Mobile Intel[®] Pentium[®] II Processor Specification Update

Release Date: July 2002

Order Number: 243887-042

The Mobile Pentium[®] II processor may contain design defects or errors known as errata which may cause the product to deviate from published specifications. Current characterized errata are documented in this Specification Update.

Old Mobile Pentium® II Processor in Mini-Cartridge Package Label with Supplier Matrix Mark

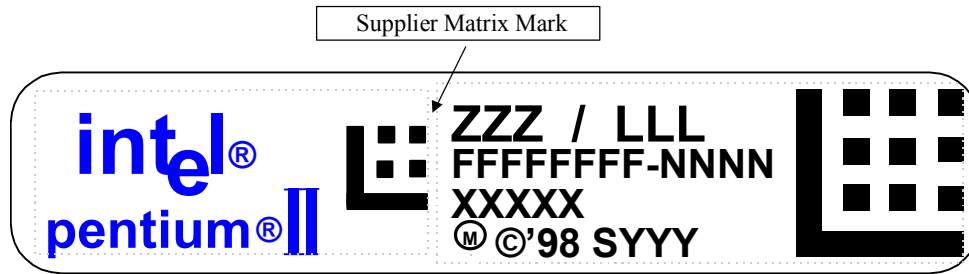
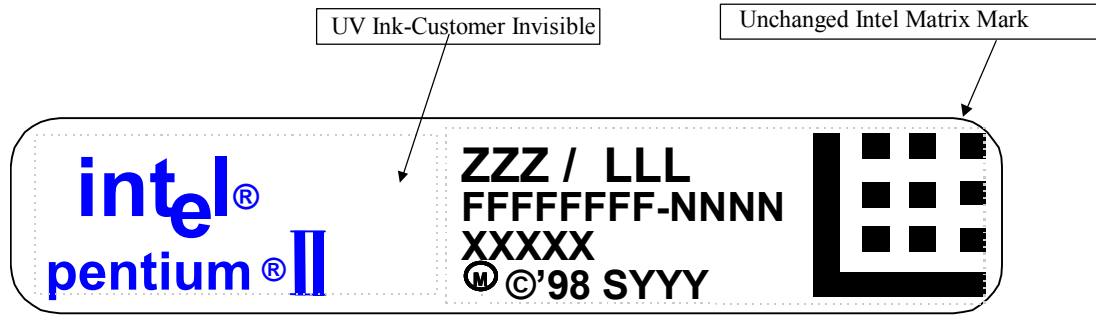
New Mobile Pentium® II Processor in Mini-Cartridge Package Label with Supplier Matrix Mark Removed

Figure 1. V_{CC}/V_{CCP} Timing Requirements (Mobile)

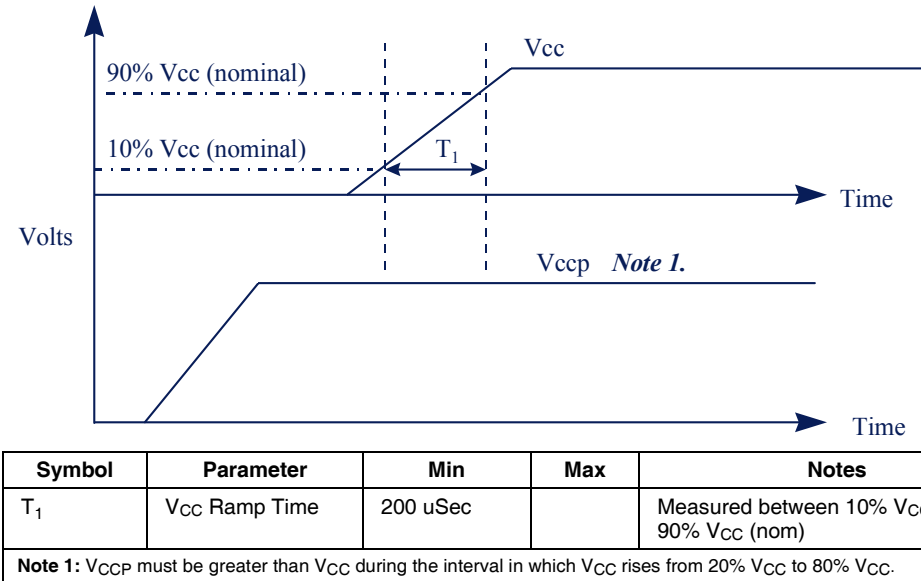
Problem: The processor uses the PWRGOOD signal to ensure that no voltage sequencing issues arise; no pin assertions should cause the processor to change its behavior until this signal is asserted, when all power supplies and clocks to the processor are valid and stable. However, if V_{CC} ramps up before V_{CCP} , it will cause the processor to enter an invalid state.

Implication: If this erratum occurs, the system may boot normally however, the L2 cache may not be initialized.

Workaround: For Mobile Pentium II processors, ensure that V_{CC} ramps after or with the L2 cache IO voltage (V_{CCP}). If V_{CCP} ramps after the V_{CC} , a delay circuit can be placed on the core V_{CC} to ensure that V_{CC} ramps at the same time or after V_{CCP} as shown below in Figure 1.

Figure 2. Workaround Flowchart: SMBALERT#-Driven System

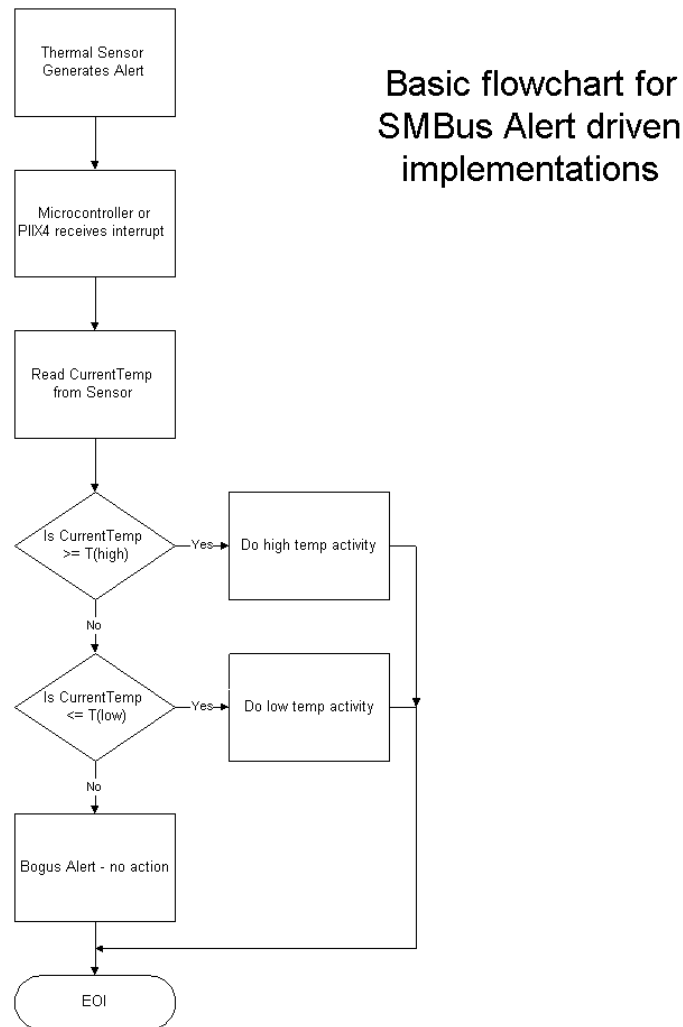
Under the conditions described below, the thermal sensor incorrectly generates the SMBALERT# interrupt. All of the following conditions must be met to trigger a false interrupt:

1. Before servicing an interrupt from the thermal sensor, read and compare the processor thermal reading with the threshold limits (T_{HIGH} or T_{LOW}). Figures 2 and 3 provide basic flowcharts for the implementation of this workaround in an interrupt driven system.
2. If the firmware implemented polls the Status Register only, then before taking any action, re-read the temperature register and do a comparison with the alarm threshold limits (T_{HIGH} or T_{LOW}) to determine if the value is actually still within the temperature window.

3. Use a temperature polling scheme to monitor the processor temperature.

Figure 1. TAP Gageable Thread Clarification

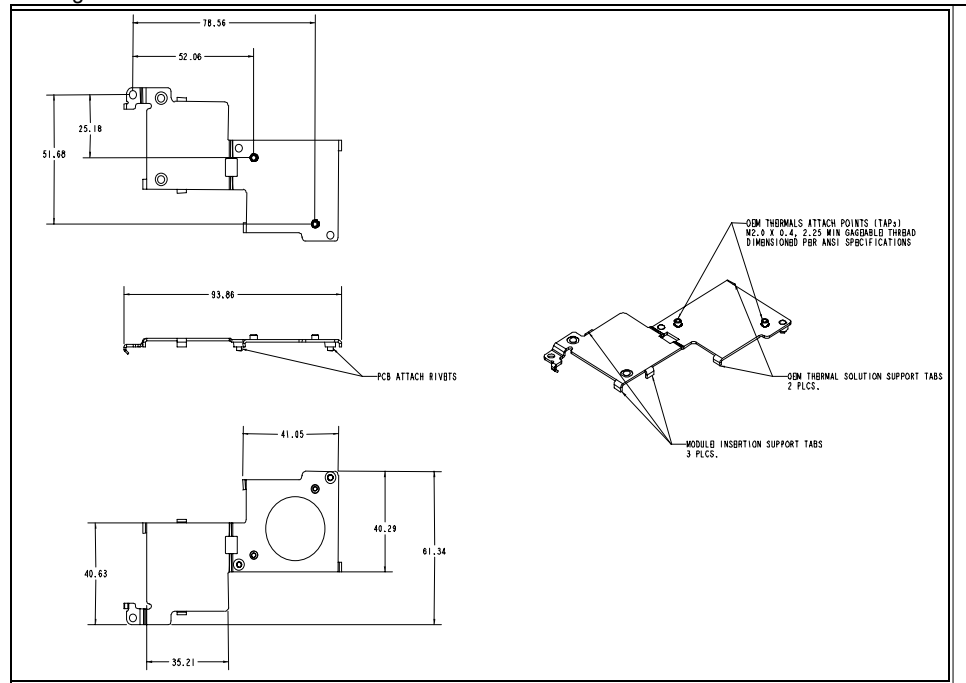
In the *Intel® Pentium® II Processor Mobile Module : Mobile Module Connector 1 (MMC-1)* and the *Intel® Pentium® II Processor Mobile Module : Mobile Module Connector 2 (MMC-2)* datasheets (Order Numbers 243667 and 243668, respectively), the thermal attach point (TAP) gageable thread specification was not clearly identified in Figure 14, of Section 5.2. The following is the TAP clarification:

OEM Thermal Attach Points (TAPs) M2.0 x 0.4, 2.25 min gageable thread dimensioned per ANSI specification.

See Figure 1 below for more information.
